Summary of Remote Control Changes

Introduction: *This document explains the differences in design and operation of the updated Breezair Remote Control (Seeley part number 110110) compared to the Breezair Freedom Remote Control. The Breezair Freedom Remote Control was granted FCC identification R2EELITE early in 2004. The changes include a software operational difference, hardware component and hardware layout differences.*

FIG 1. – Antenna Loop design and orientation

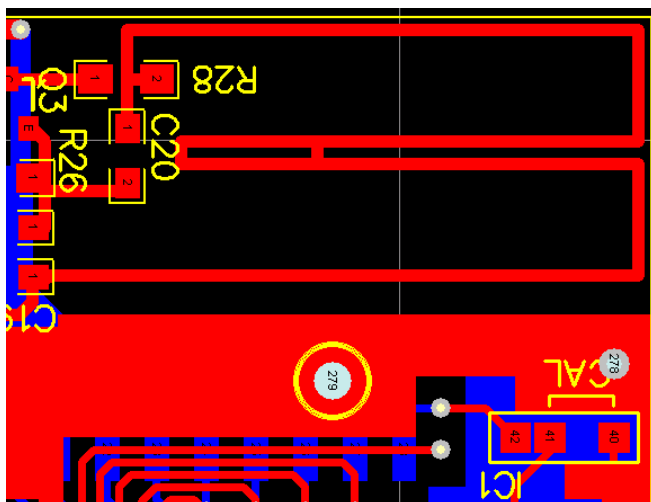
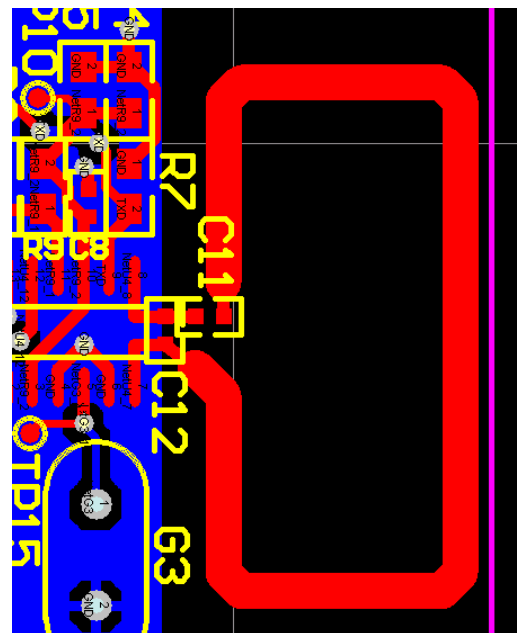
- The main micro-processor has changed from an NEC uPD17202A to a Hitachi HD64F38102FP. The communication data stream structure and Bit Rate have not changed. The NEC chip was clocked with 32kHz and 4MHz crystals, the new design is clocked with 32kHz and 3.58MHz crystals.
- The Transmitter circuitry has changed from a discrete component design to a MICREL integrated circuit MICRF104. Both circuits utilize a PCB track Loop Antenna. The MICRF104 includes in integrated constant voltage power supply.
- The Loop Antenna layout has changed according to Fig 1 below, both shape and orientation on the PCB. Orientation is as shown below.
